# SERVICE BULLETIN

SERVICE BULLETIN NO. 226

### *Kodak AUTOMATIC FILM FEEDER, MODEL RA*

#### **DIP SWITCH Location Changed on the ADJUSTMENT CIRCUIT BOARD**

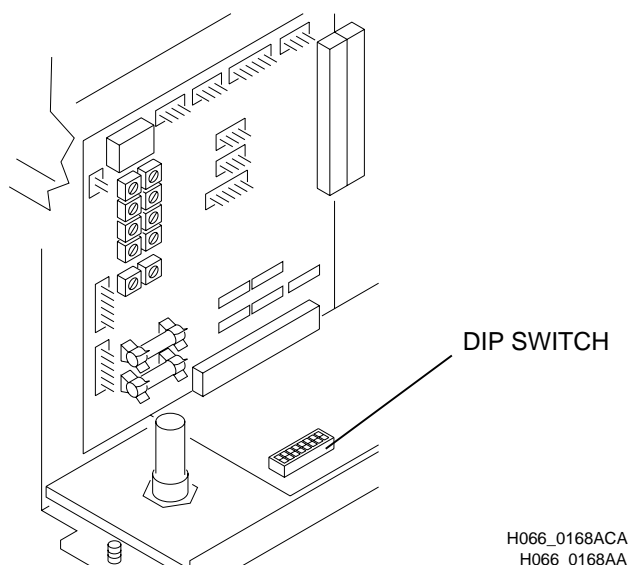
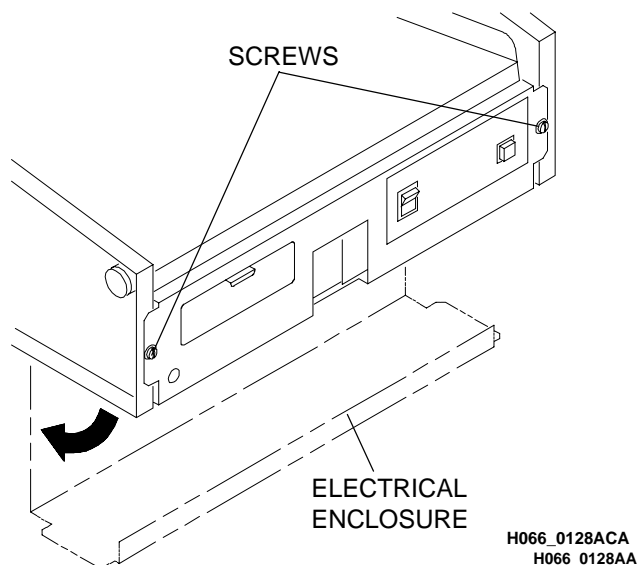
To reduce the effect of electrostatic discharge on the FILM FEEDER, the DIP SWITCHES have been relocated on the ADJUSTMENT CIRCUIT BOARD. On current units, the SWITCHES are located on the ADJUSTMENT CIRCUIT BOARD so that they are inside the ELECTRICAL ENCLOSURE. See the illustration. The DIP SWITCHES are not accessible through the FRONT PANEL.

On FEEDERS with Serial No. 50,899 and above, the DIP SWITCHES are inside the ELECTRICAL ENCLOSURE. See the figures below.
